ORIGINATION FORM

Proposed Revisions to a Standard Plans Index
(Please provide all information — Incomplete forms will be returned)

Index Number: 521-610
Sheet Number (s): 1
Index Title: Concrete Barrier/Junction Slab - Wall Coping

REVISION	DESCRIPTION	FY 2021-22	CONCRETE BARRIER/JUNCTION SLAB	INDEX	SHEET
11/01/20		STANDARD PLANS	- WALL COPING	521-610	1 of 3

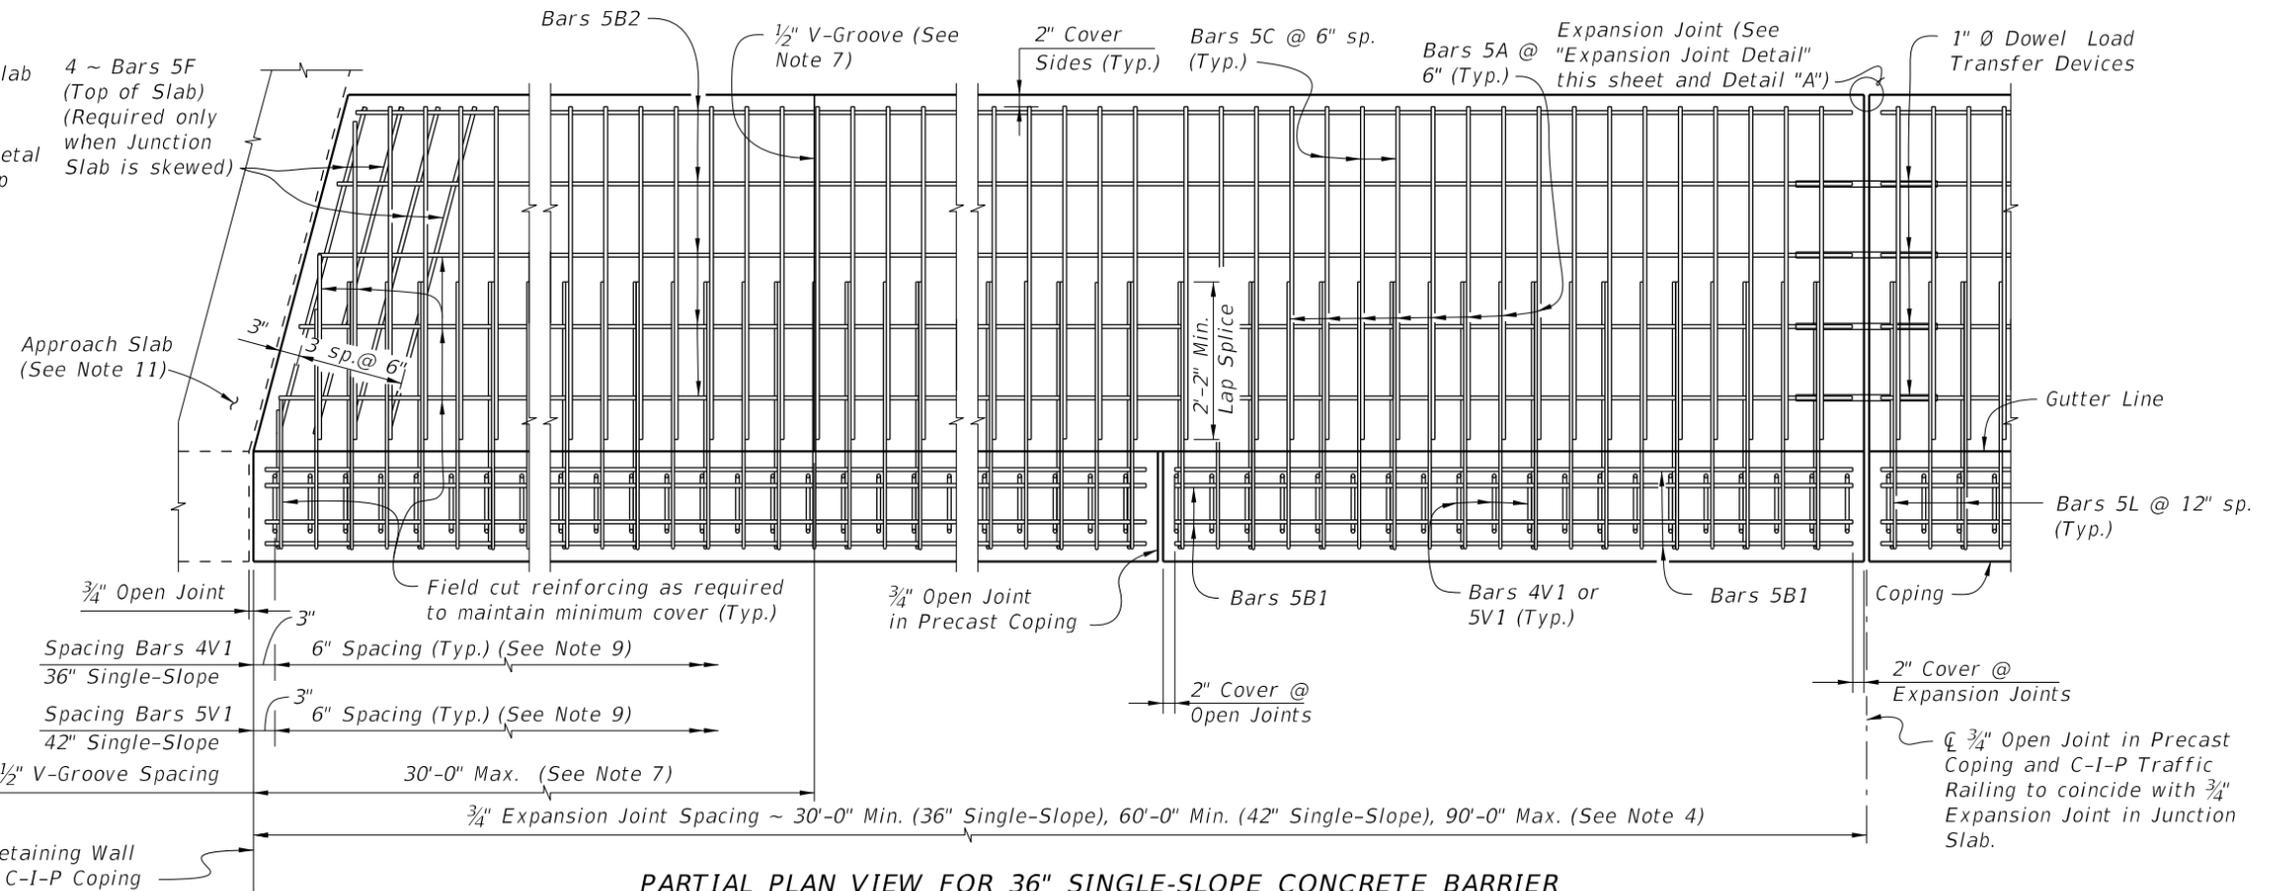
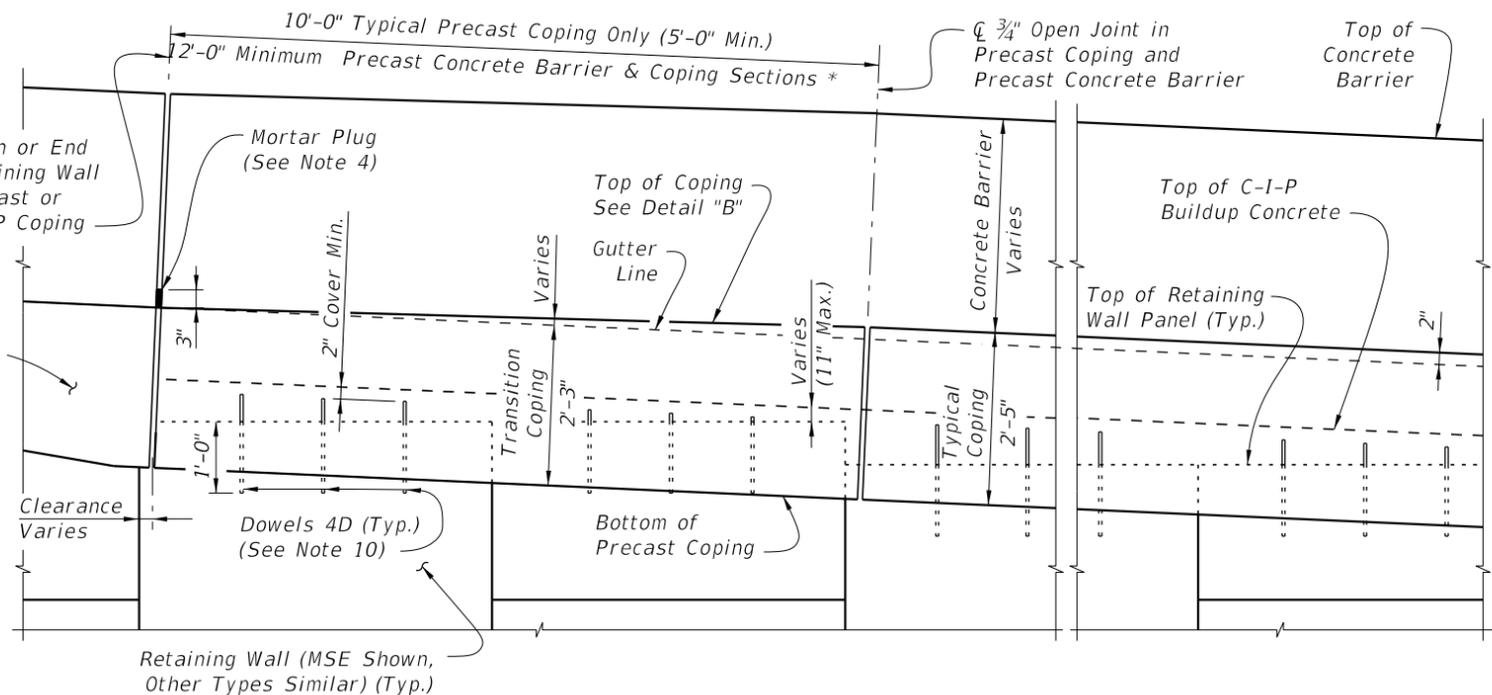
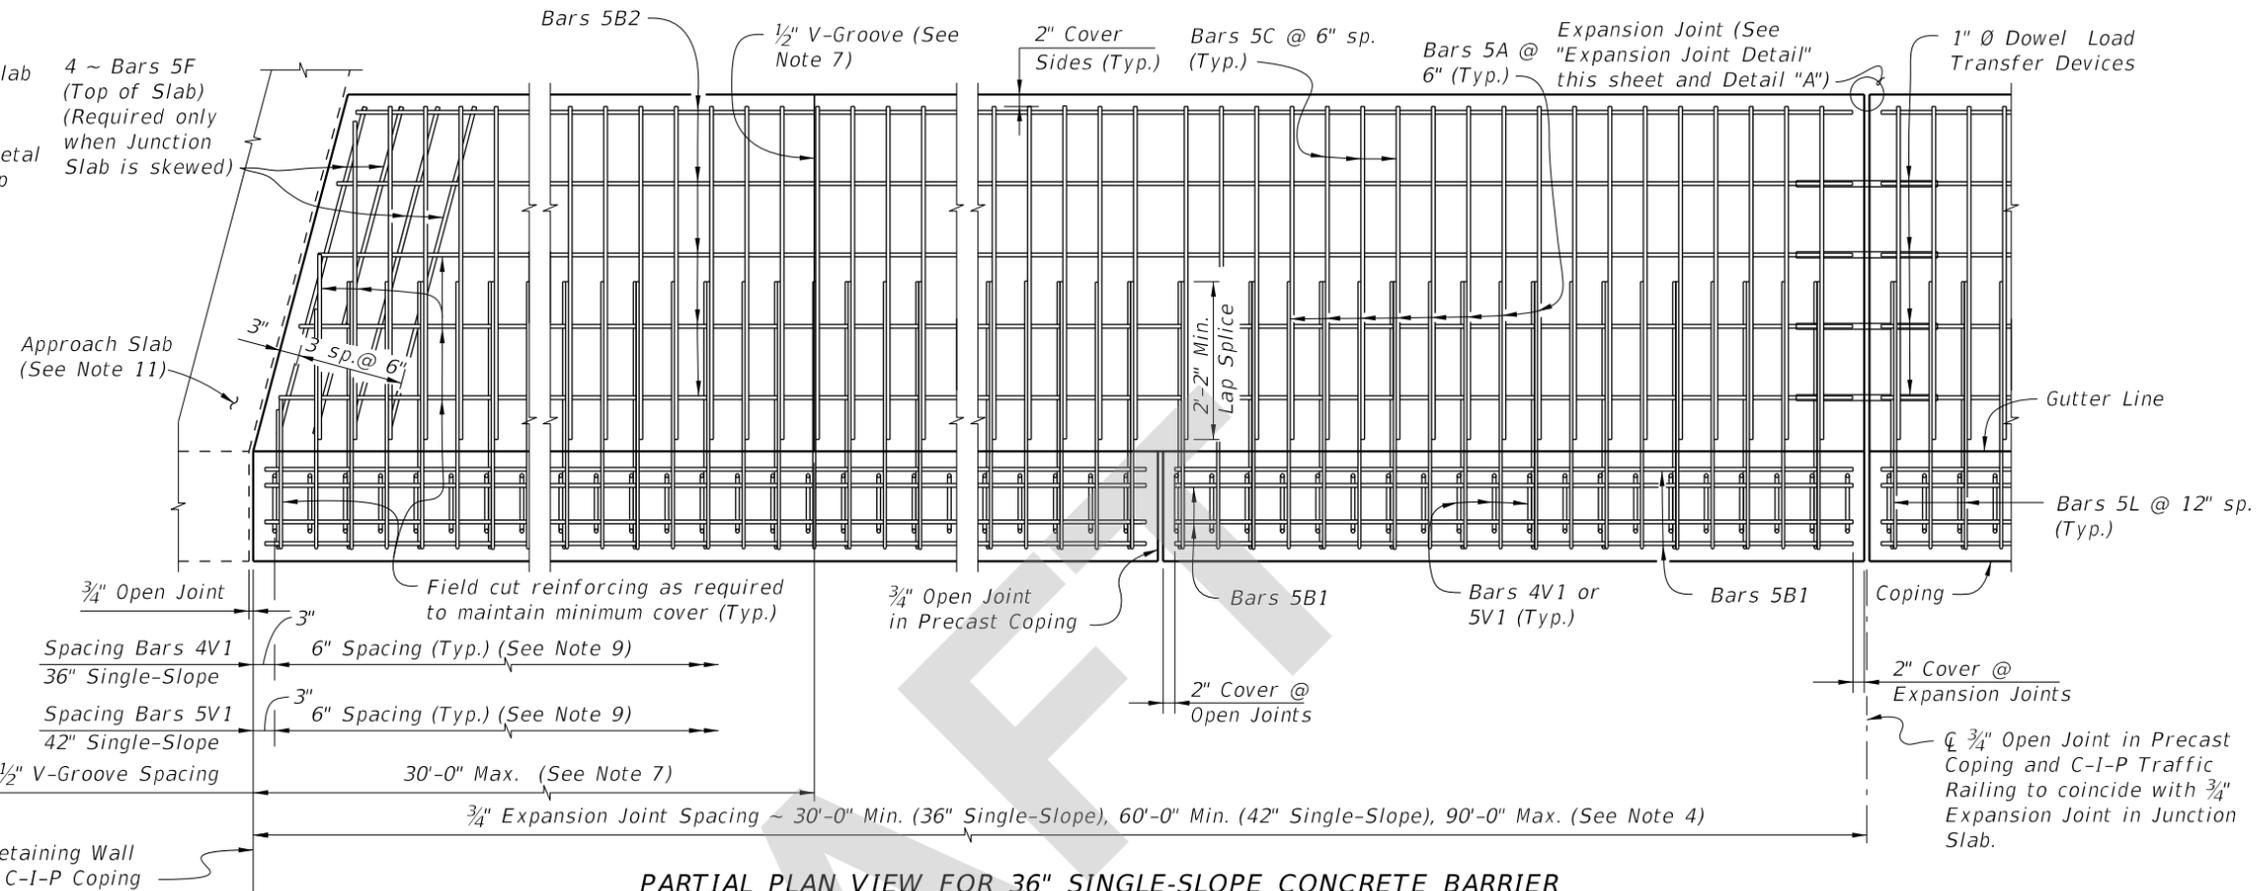
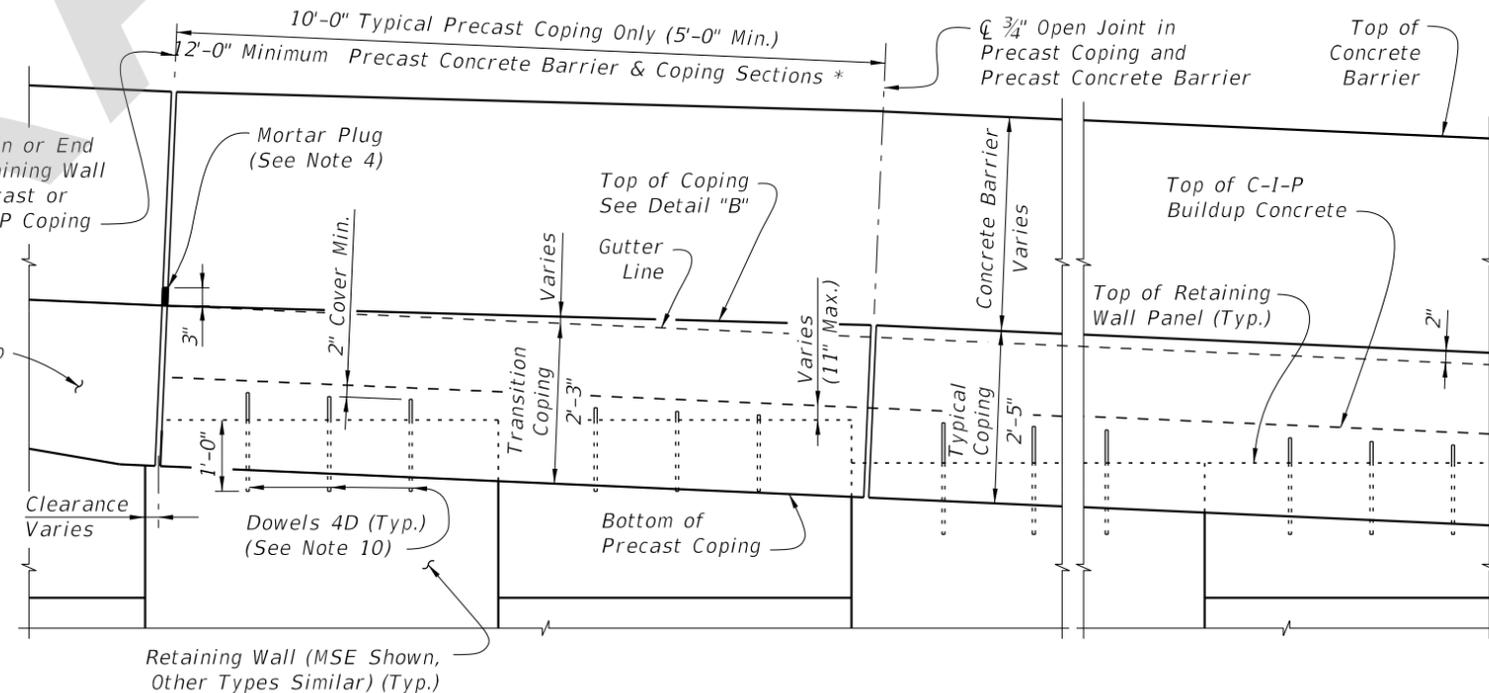
Sheet 1, Note 15: Added reference to Index 630-001 (Conduit Details - Embedded) for information on embedded junction boxes and conduits.

Added reference to provide continuity between Standards and improve understanding for designers and contractors wanting to verify that these Indexes share details. This particular topic received designer questions. This is consistent with the Traffic Railing standards.

15. For embedded conduit and junction boxes, see Index 630-010.

- For embedded conduit and junction boxes, see Index 630-010.
